# Issue Specific Hearing 5 Landscape and Visual Impact and Design on behalf of Theberton and Eastbridge Parish Council, Stop Sizewell C and Minsmere Levels Stakeholders Group

### **Oral Contribution by Cllr. Paul Collins**

#### **Landscape and Visual Impact and Design Issues**

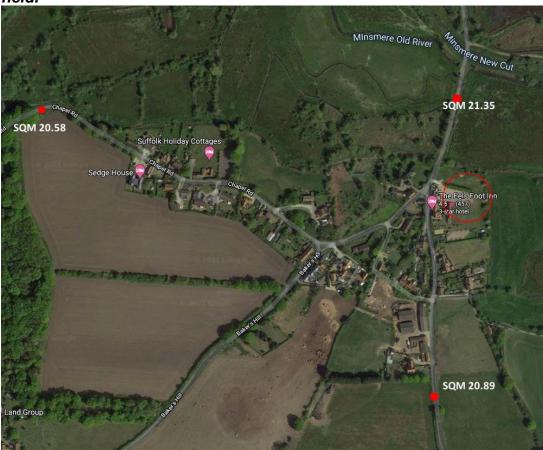
- The area north of the construction site at Eastbridge has recently had an initial dark skies assessment of between 20.58 and 21.35 SQM (Unihedron Sky Quality Meter) and will be reassessed in the autumn around a new moon but the measurements so far indicate that the skies are at least Rural Sky, sufficient for complex Milky Way quality observation and the current skies may well reflect a Truly/Typical Dark site when measured later in the year.

- Faced with similar night-time glows as at HPC, these skies are likely to be significantly downgraded to rural/suburban transition at best.
- As supporting information, I have included the initial assessment for dark skies that will be updated later this year.

- The point marked with SQM 20.89, bottom right, is about 150m from the closest borrow pit.
- This point was also raised by the Mr Collinson of National Trust with respect to Coastguard Cottages where night sky events are held.
